**Industrial Area and Buffer Zone  
Sampling and Analysis Plan  
Modification 1**

**May 2004**

Approval received from  
the Colorado Department of Public Health and Environment and  
the U S Environmental Protection Agency  
( )  
Approval letter contained in the Administrative Record

**Figure 20**  
**Data Quality Filter for the Industrial Area and Buffer Zone Sampling**  
**and Analysis Plan**

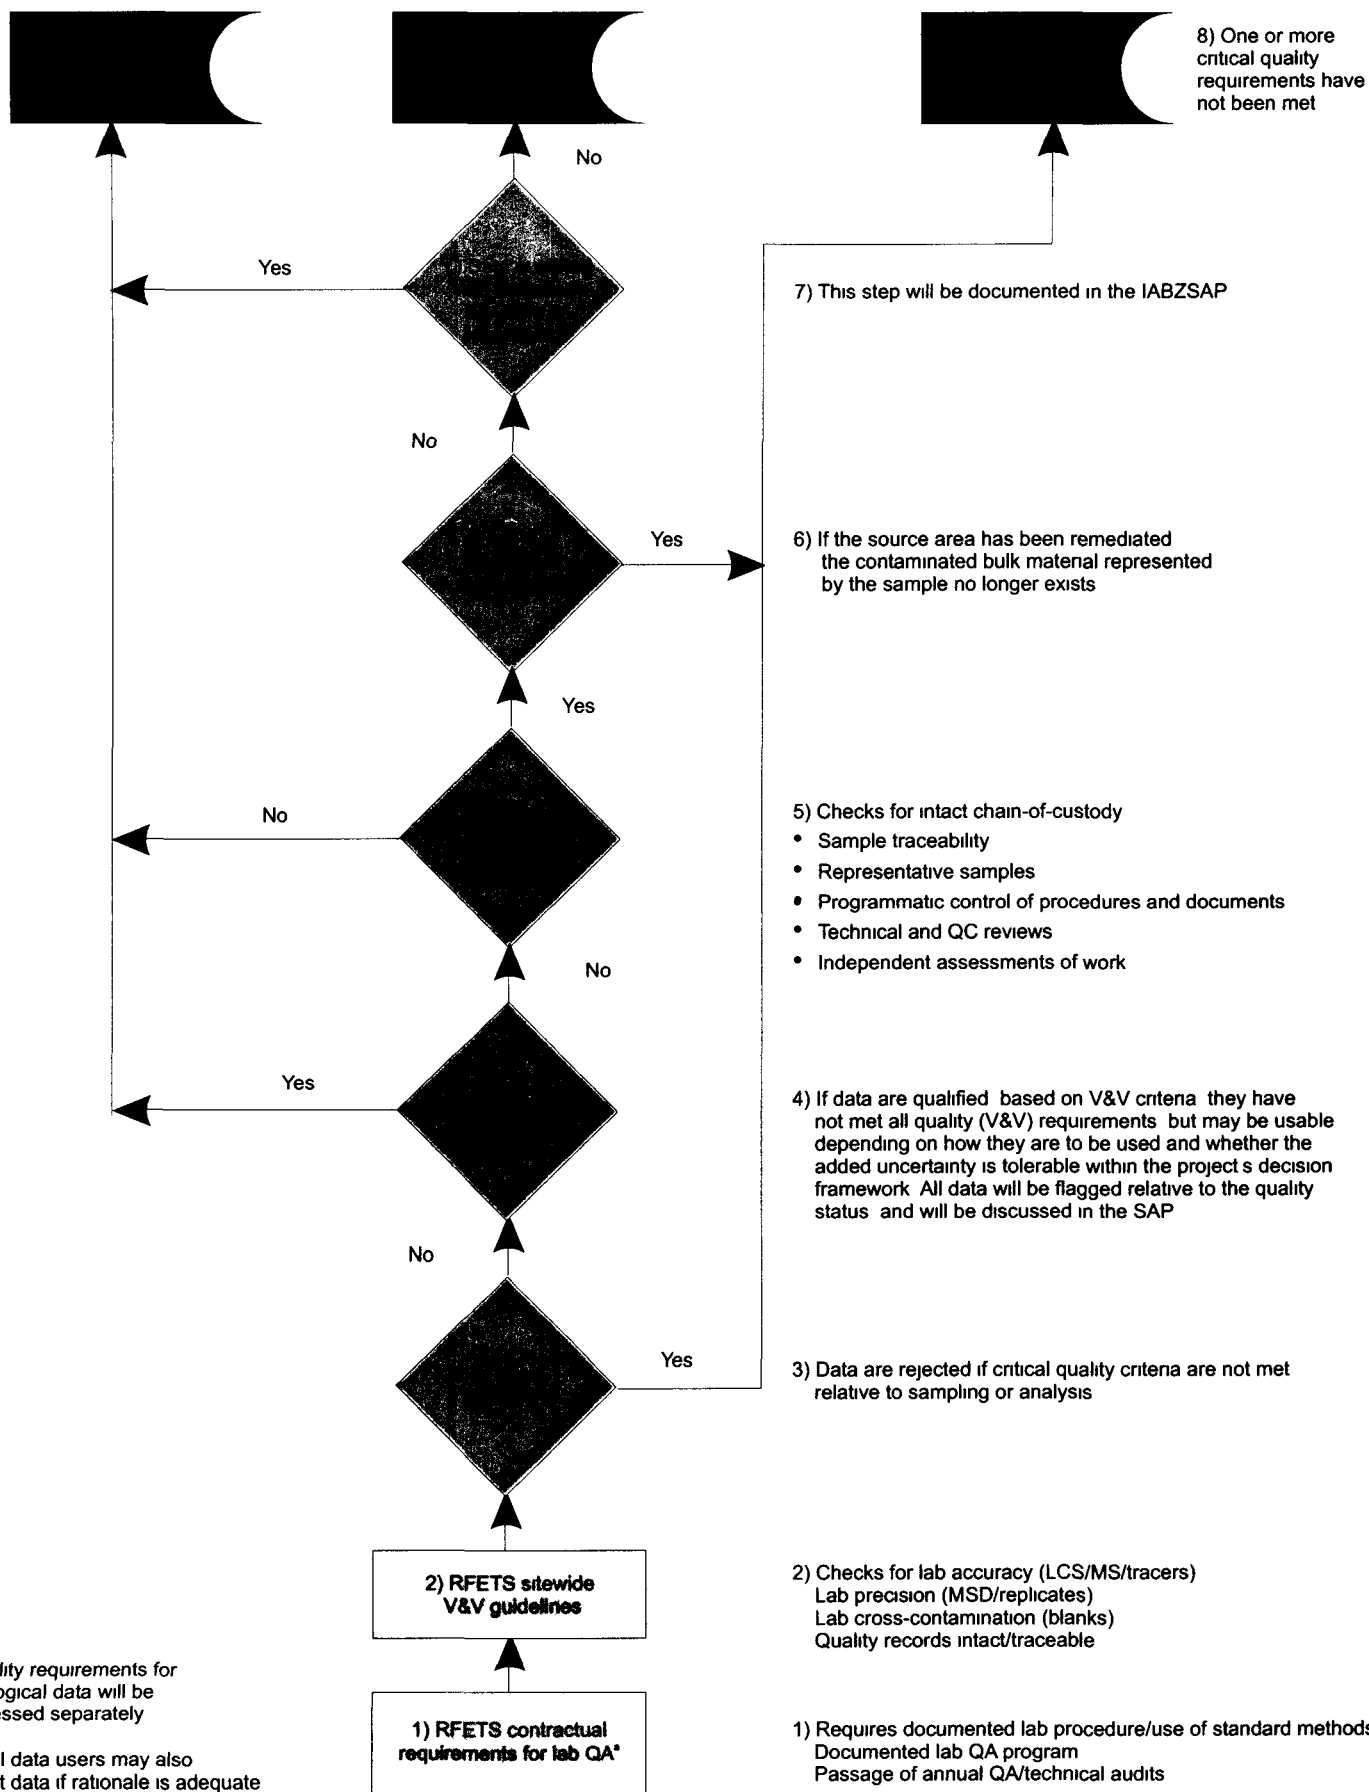
11	<p><u>Figure 20</u> The process in this figure goes beyond determining the extent of an AOC and should be limited to that process or it should be re-titled. It is unclear what is meant by “Manage or Evaluate” to the right of the decision diamond asking, “Is remediation needed?”</p>	<p>Figure 20 (now Figure 19) encompasses both the initial AOC determination based on existing data and the final AOC determination based on characterization and/or confirmation data  Figure 20 (now Figure 19) was modified to reflect multiple OUs. The title is correct, however it was changed to “Initial and Final AOC Determination” to more accurately reflect the contents of the Figure. The “remediation” box was changed to “no further accelerated action” (page 45)</p>

**Figure 27**  
**Standard Statistical Sampling Process**  
**for IHSSs, PACs, and UBC Sites**

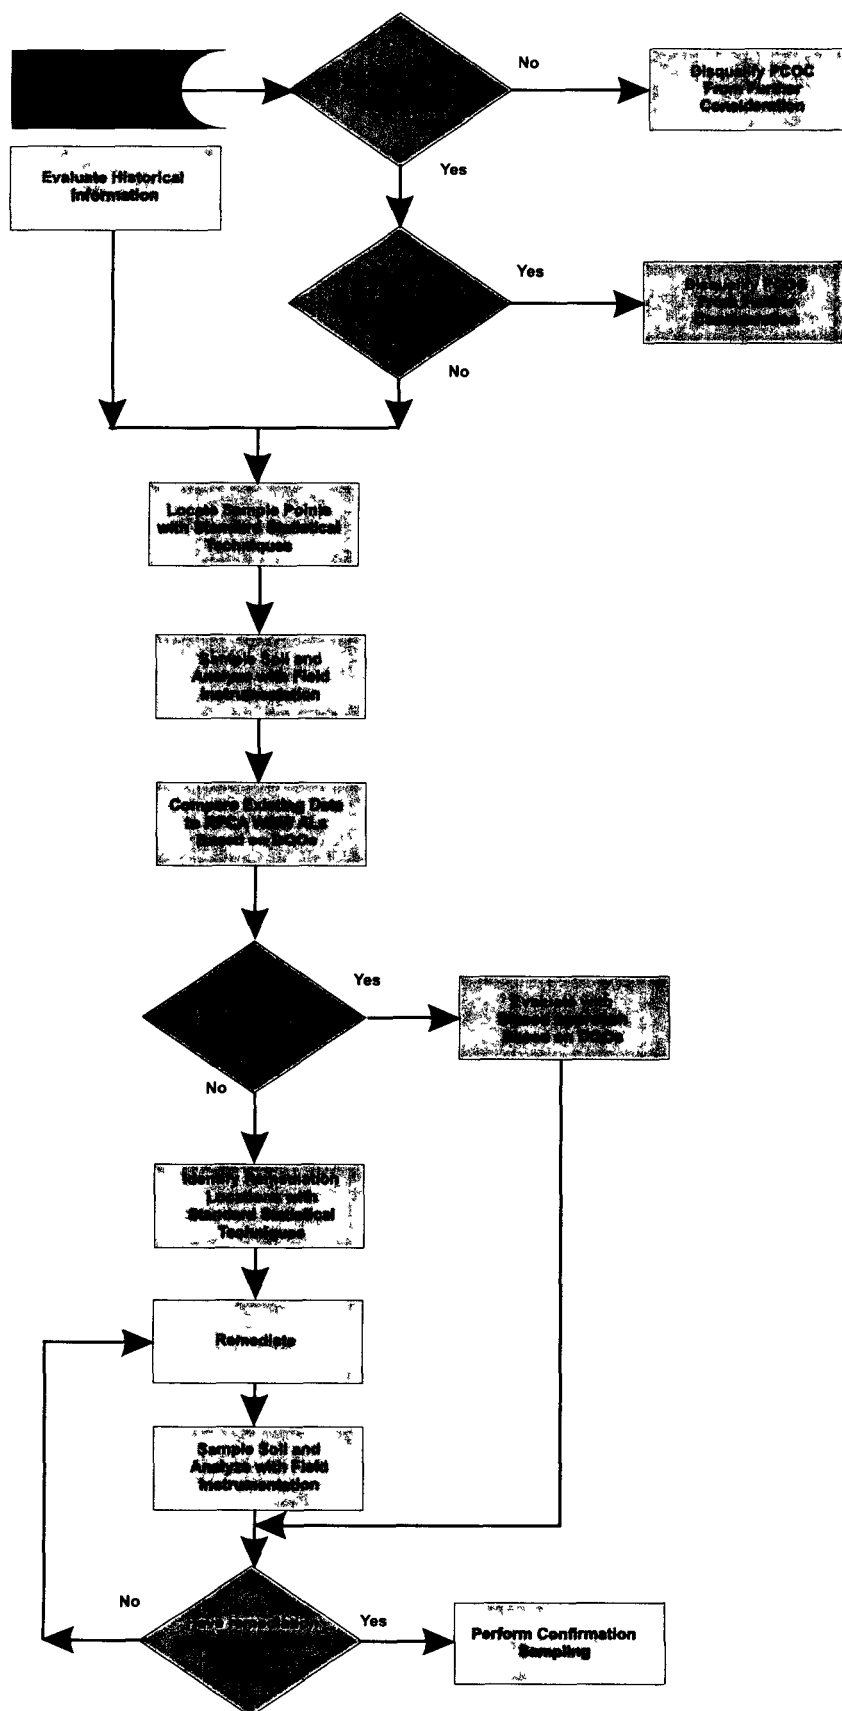
20	Section 4 0 (page 66) Figure 25 does not show IHSSs, PACs, and UBCs as implied in the first bullet	The text in Section 4 0, paragraph 1, bullet 1 was changed to "Figures 1 and 2" (page 59)
21	Figures 26, 27, and 28 In these flow diagrams, PCOCs are eliminated and hot spots are evaluated before sampling begins	These diagrams (now Figures 25, 26, and 27) are used to describe the process, using existing data, to determine sampling locations Please refer to Figure 35 for information on when hot spots are evaluated  The words "hot spot" on these diagrams was changed to "localized areas of elevated PCOC concentration" Additionally, the text of the lead-in box (Figure 20) was clarified
22	Section 4 2 2 (page 73) The paragraph which begins, "This methodology will provide " could be added to the end of the second method of developing statistical grids The next paragraph, which begins "At UBCs and IHSSs or PACs ", could become method #3	The paragraph break in Section 4 2 2, between bullet 2 and the next paragraph was removed The second paragraph break in Section 4 2 2 was removed and the text is now part of Method 2 (page 66)

Figure 14  
Individual Hazardous  
Substance Sites  
Operable Unit 10

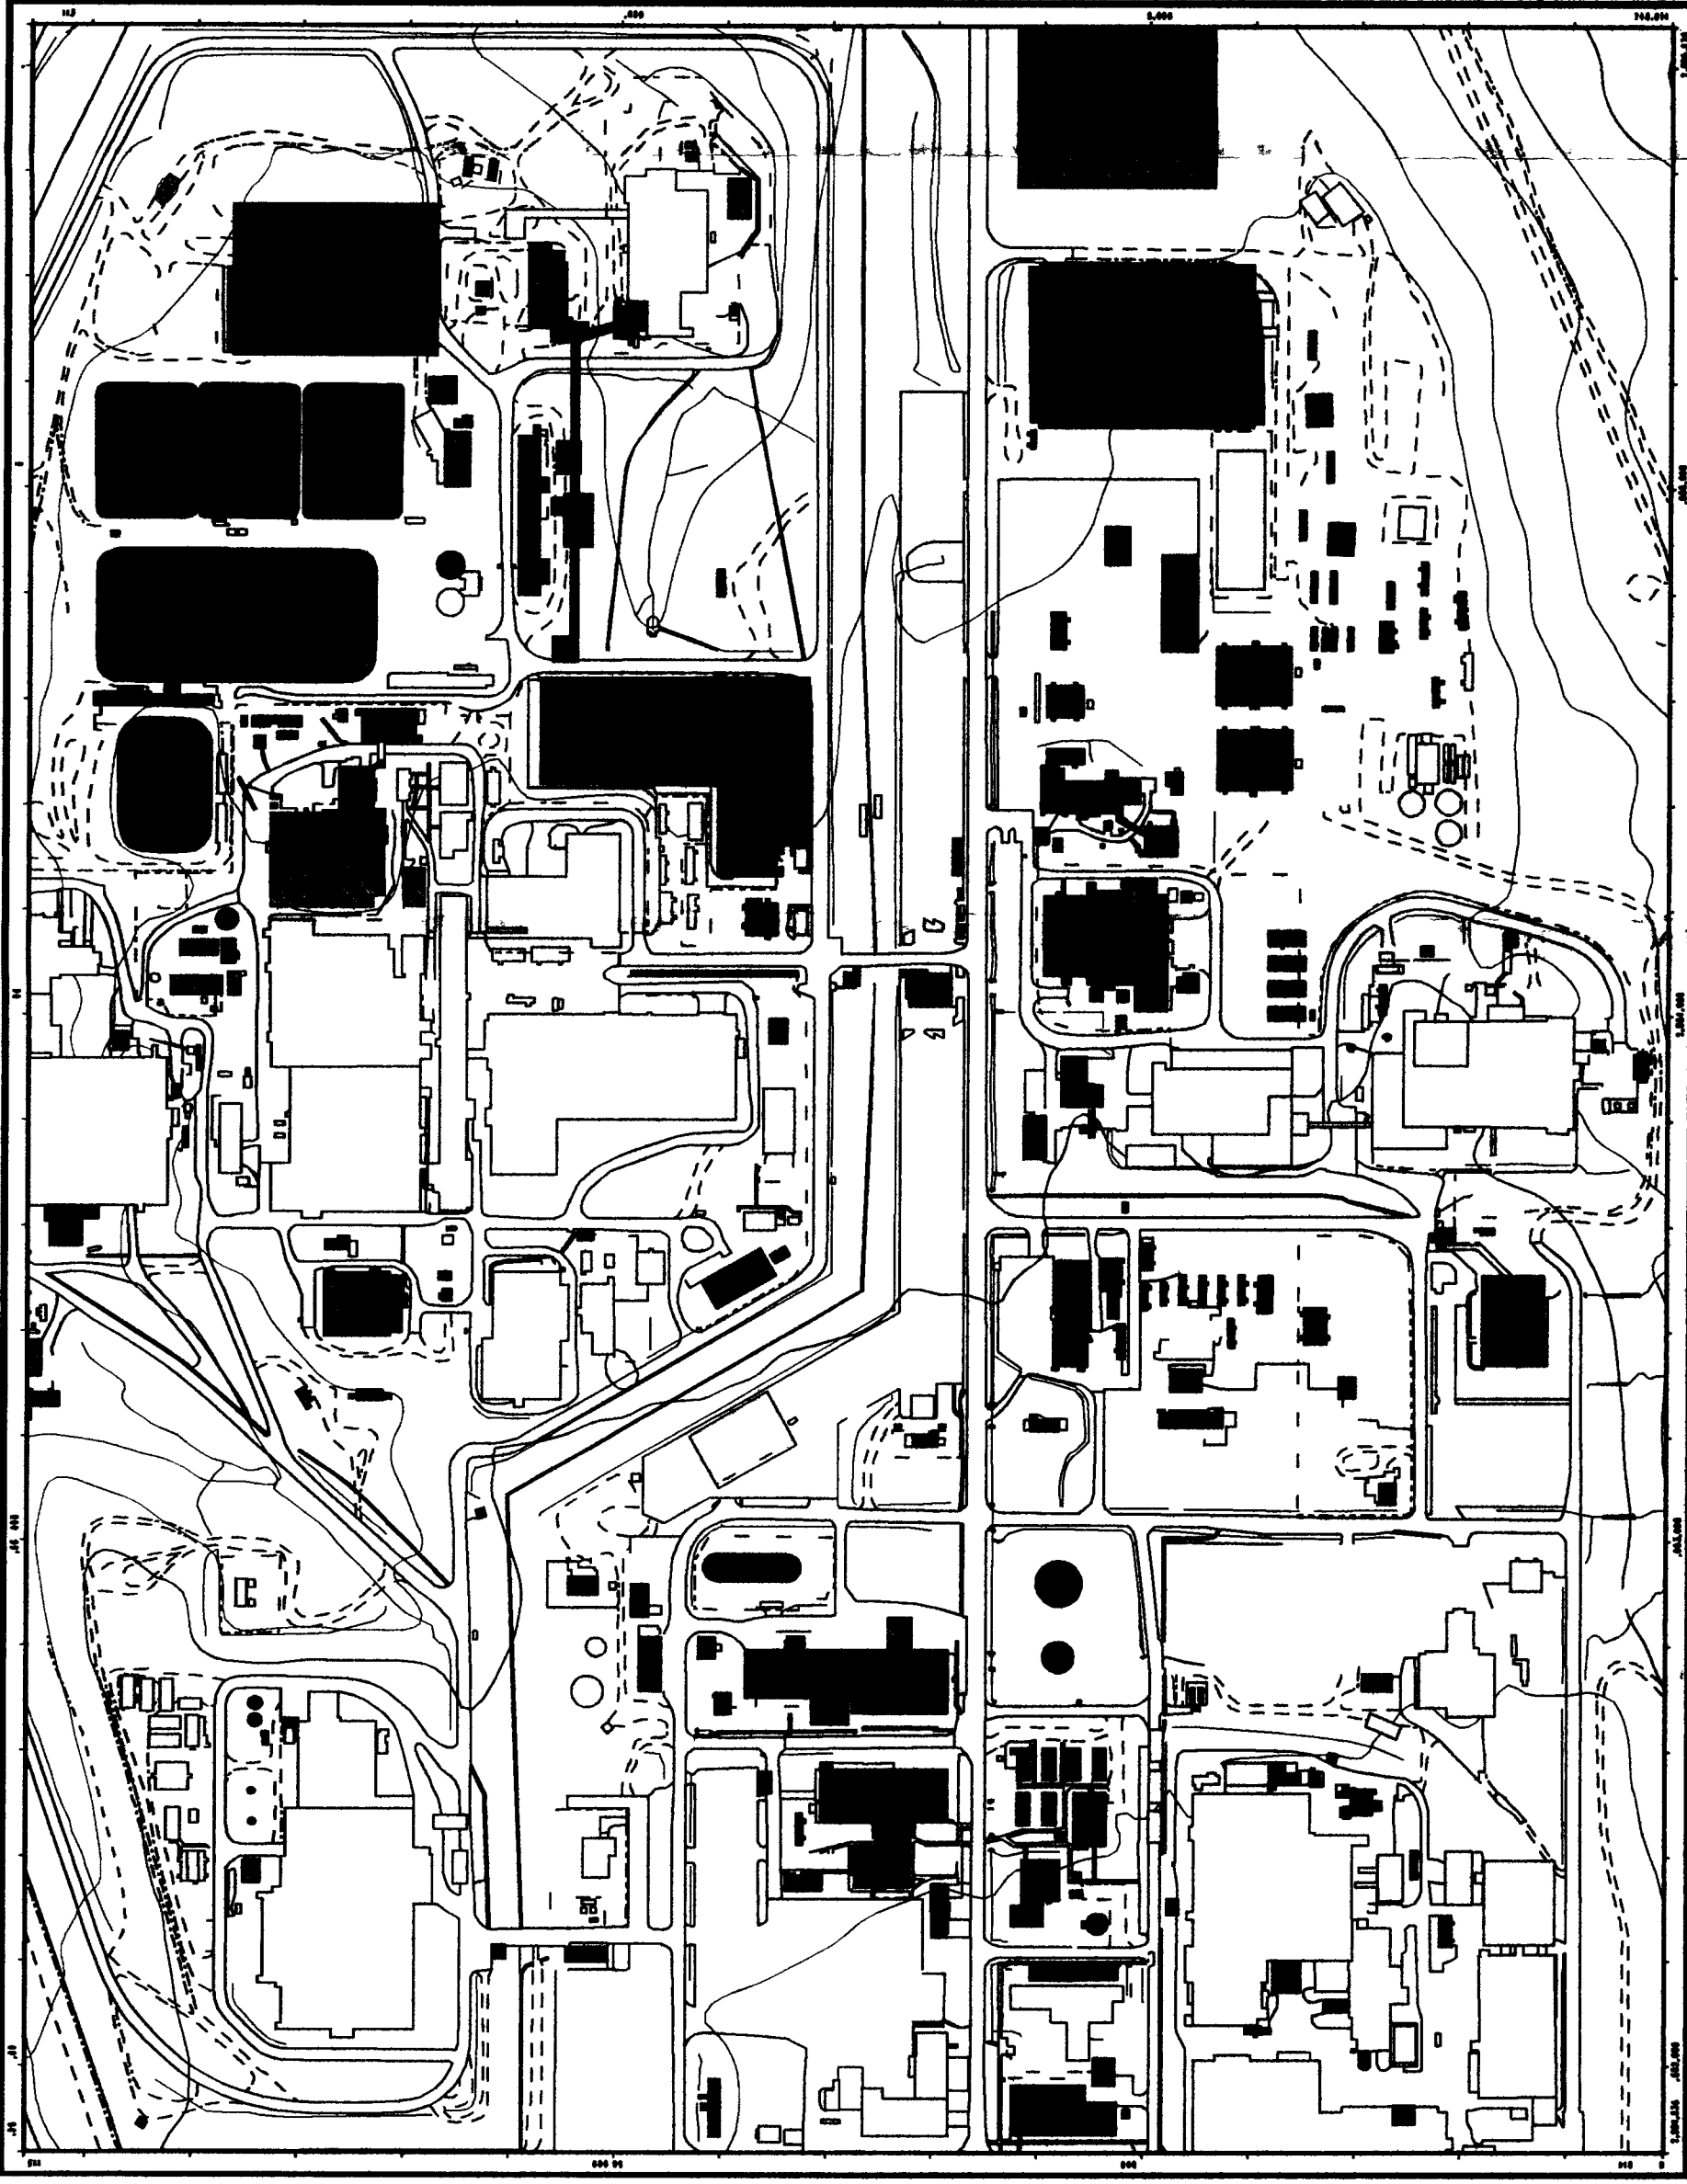
5	<p><u>Figure 14</u> The OPWL lines on this map do not agree in some places with the maps being used for the OPWL characterization and remediation projects. The map does not necessarily have to be replaced, however</p>	<p>The OPWL maps are continuously updated as work progresses No action is necessary</p>
6	<p><u>Section 3.1 (page 43)</u> This section lists four purposes for the data collected under these DQOs. An inherent purpose in #3 is to determine where additional data collection outside of IHSSs (areas formerly known as White Space) may be necessary to adequately support the CRA. The IABZSAP should acknowledge that the data adequacy process in the CRA Methodology (which has now been removed as Appendix D) may identify the need for additional data collection under its own set of DQOs</p>	<p>CRA DQOs are not addressed in the IABZSAP they will be included in the CRA Methodology. The CRA Working Group has not yet finalized the CRA Methodology or DQOs. A data gap analysis is being conducted to determine if additional sampling to meet CRA requirements is required.</p> <p>The following text was added to Section 1.2, paragraph 3 “While the IABZSAP describes sampling methods for CRA sampling, specific CRA DQOs are described in the CRA Methodology. Separate CRA sampling addenda will be developed to describe CRA sampling in accordance with CRA DQOs” (page 7)</p>
